# PLAN COMMISSION STAFF REPORT

Agenda Item: PC Docket No. 20-009

**Summary:** Guy Costanza/GM Contracting requesting modifications to the building frontage

at 407-411 Ridge Road.

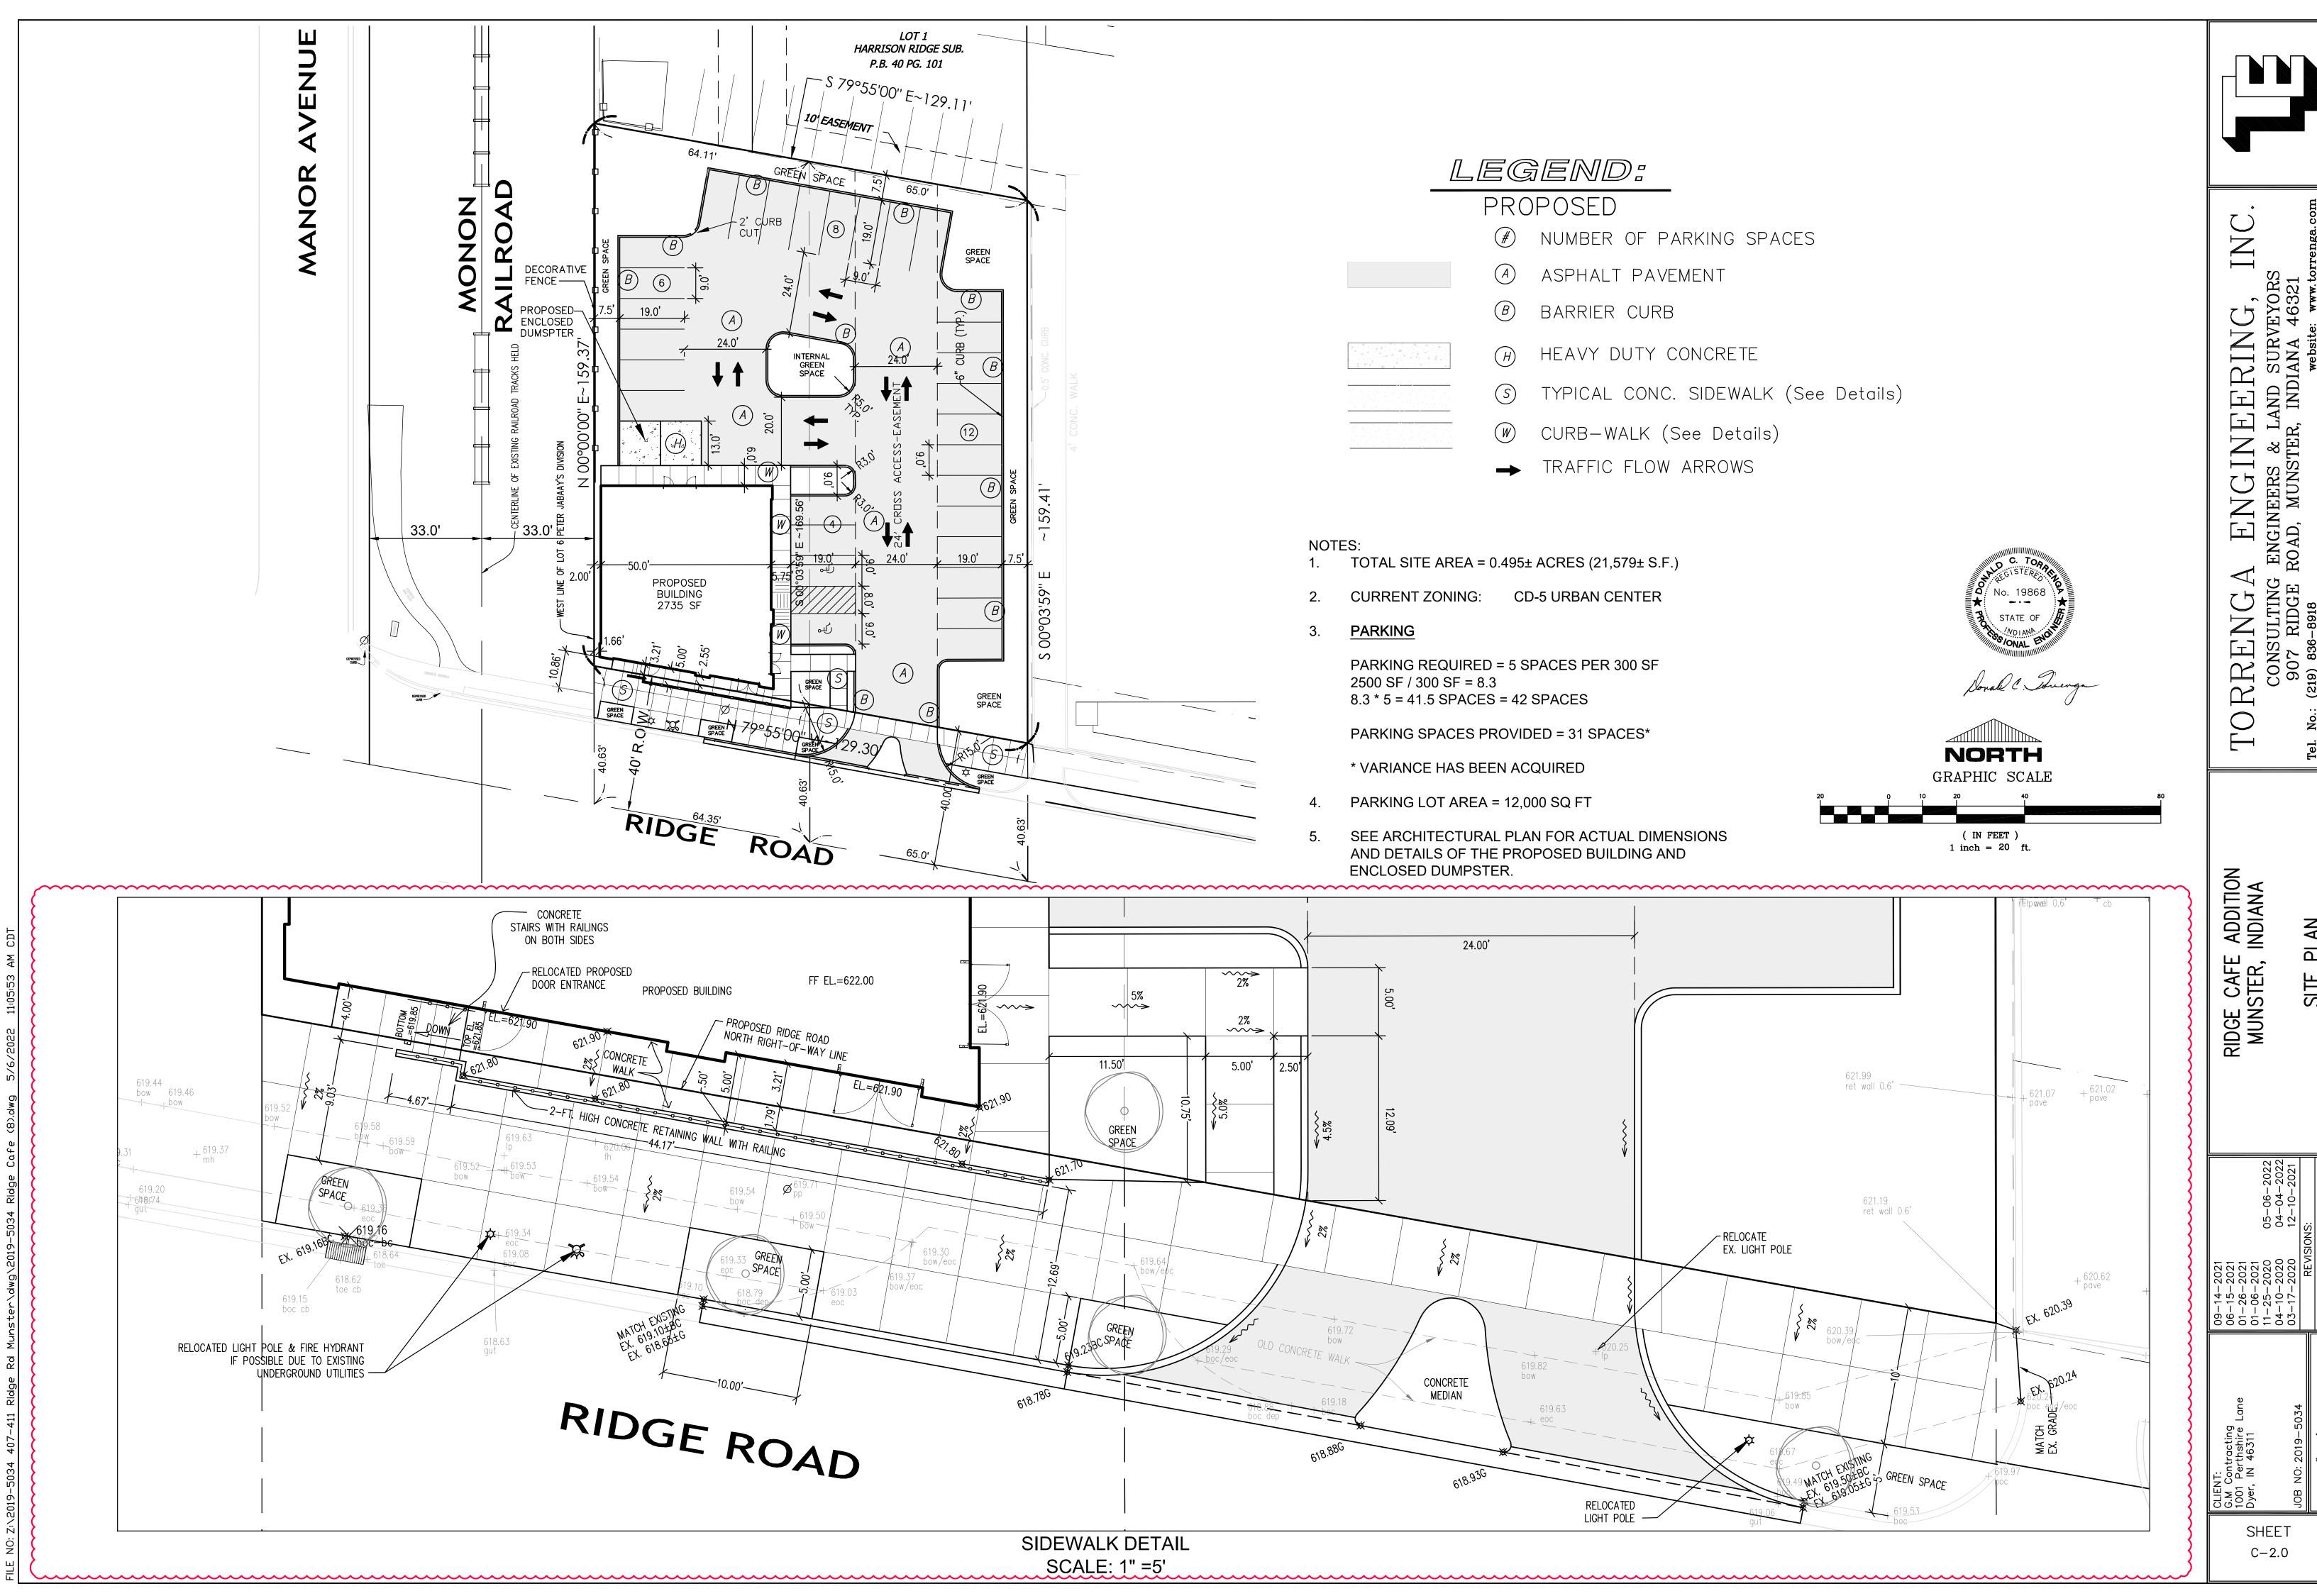
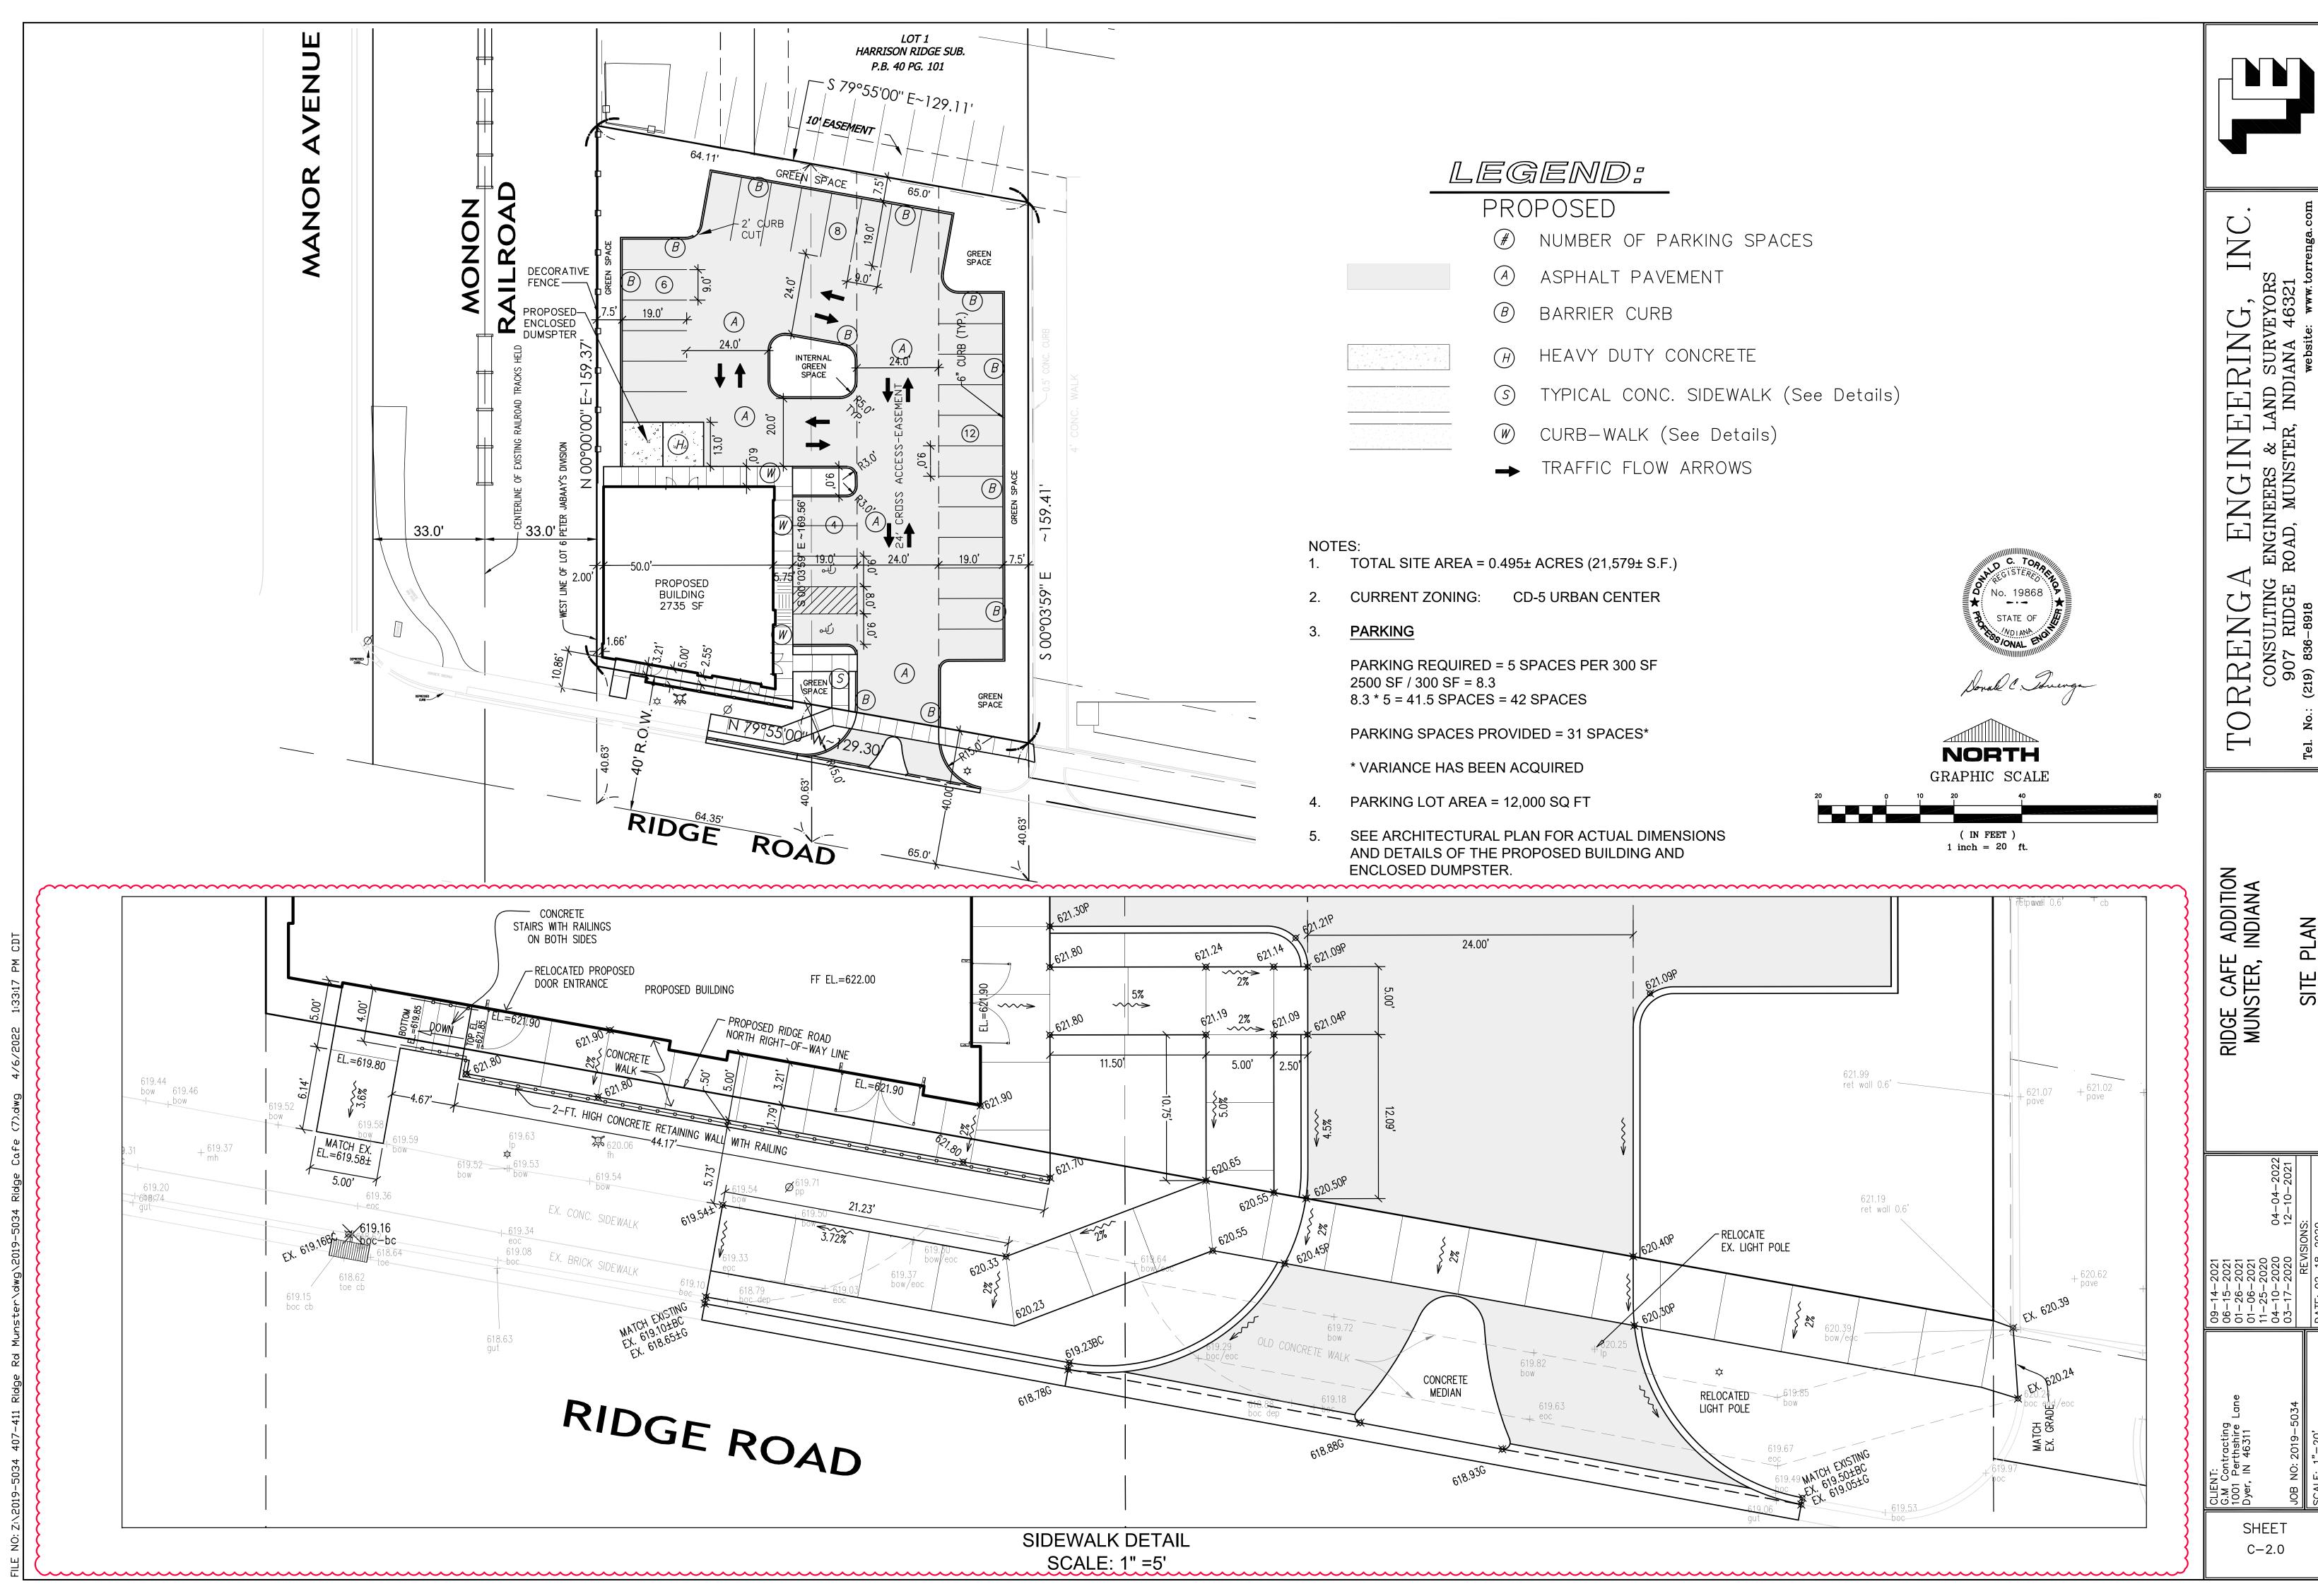
1. The finished floor level is approximately two feet higher than the sidewalk grade. A concrete stoop that encroaches into the public right-of-way approximately two feet has been proposed to

provide access to the front doors. The stoop and the encroachment are acceptable to the Town with the following conditions: the stoop shall be brick to match the building, the entirety of the right of way in front of the building will be paved as a concrete sidewalk meeting Town specifications, the fire hydrant and the light pole will be relocated to a utility zone approximately two feet from the curb, open planters will be installed in the utility zone with shade trees to be installed every 30 feet. NIPSCO is removing the power pole in connection with the NICTD project.

2. An easement, additional right of way dedication, or other agreements are required to permit the encroachment and to permit public access to the stoop. The agreements should shield the Town from liability if a pedestrian is injured on the stoop or stairs and provide for maintenance and Dave Wickland and John Reed will prepare the documentation.

Staff recommends approval of the attached plan dated 05.06.2022 upon the following conditions:

- 1. The plans are subject to a final review by the Town Engineer.
- 2. Along the west side of the building, earth will be sloped up around the foundation and the brick ledge will be cut down so brick can be installed to cover all unfinished concrete to the finished grade.
- 3. A revised landscaping plan be submitted for Town staff approval.
- 4. The south storefronts be modified with recessed entries, so the doors do not open into the walking path.
- 5. The stoop be constructed of the same masonry used on the building.
- 6. If possible, stairs be added to connect the east side of the stoop to the public sidewalk.
- 7. A public sidewalk easement be recorded for the stoop area south of the building or it be dedicated to the Town of Munster as public right-of-way as determined by the Town Attorney.
